DRB MEETING

1. **CALL TO ORDER - 7:00 PM**
2. **ADDITIONS, DELETIONS, OR CHANGES TO THE AGENDA**
3. **PUBLIC HEARINGS**
 - A. DRB-0013-26, RenoVermont LLC, Sketch Plan Review
 - B. Cline Road LLC, Preliminary Plat for 32- Lot/30-Unit PUD Subdivision
4. **APPROVAL OF MINUTES**
 - A. DRB Meeting Minutes, April 21, 2026
5. **OTHER BUSINESS**
 - A. SUB-012-2026, Dunsmore Two-Lot Administrative Subdivision
6. **PLAN NEXT MEETING AGENDA**
 - A. June 2, 2026
7. **DELIBERATIONS**
 - A. DRB-009-2026 Decision Letter, RenoVermont LLC Three-Lot Subdivision
8. **ADJOURN**

**SKETCH PLAN REVIEW #2
Three-Lot Minor Subdivision
DRB-013-26**

Cline Road, LLC, hereafter referred to as Applicant, is requesting Preliminary Plat review for a 32-lot/30-Unit Major Planned Unit Development (PUD) subdivision located off Cline Road and Horseshoe Barn Road in the AR zoning district. The ±94.49 acre parcel consists of agricultural fields and wooded areas, of which 60 acres will be used to create the PUD and the remaining 34 acres retained as undeveloped lands. The proposed subdivision will be accessed via an existing curb cut across from 891 Cline Road.

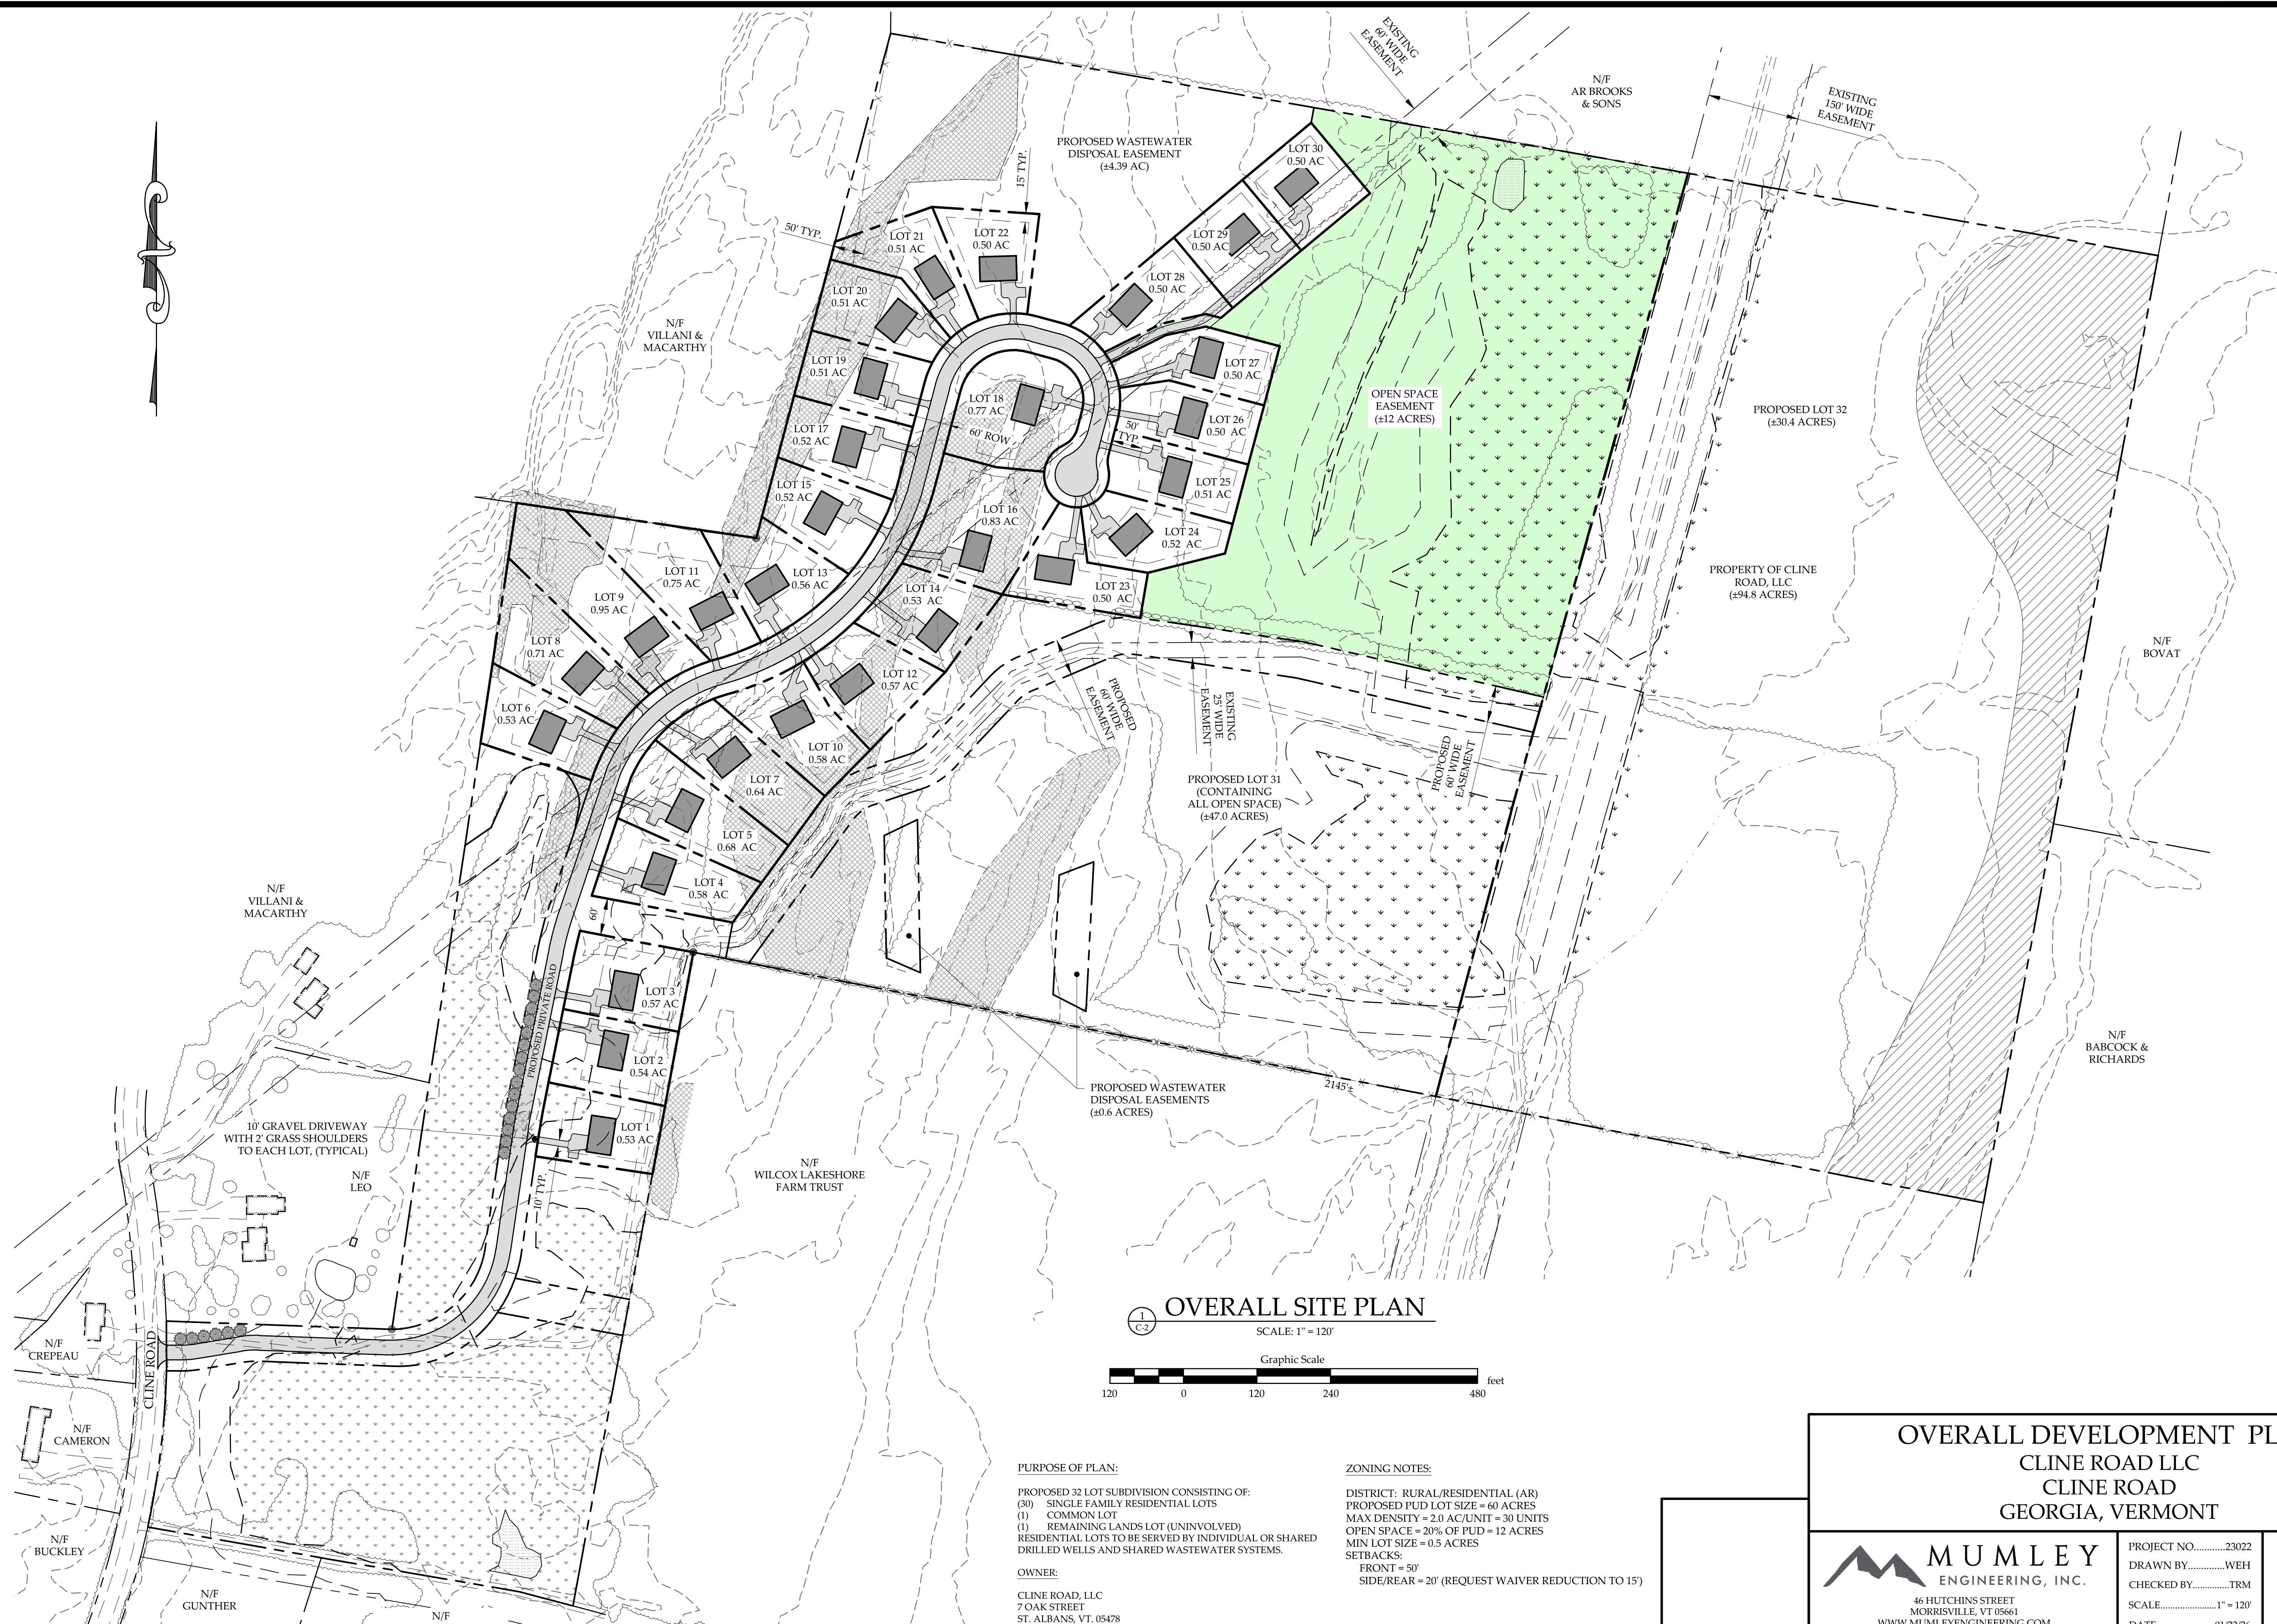
16. **Landscaping Plan and Lighting.** Applicants have added more screening to Lots 1-3. Note, the sketch decision seemed to suggest continuous screening all the way from Cline Road to Lot 3. Our opinion is that a large portion of this screening would have no function and is an unreasonable burden on both the developer and HOA going forward to maintain this. Applicants believe this current proposal is a good faith effort to alleviate the screening concerns from neighbors for these first three lots.
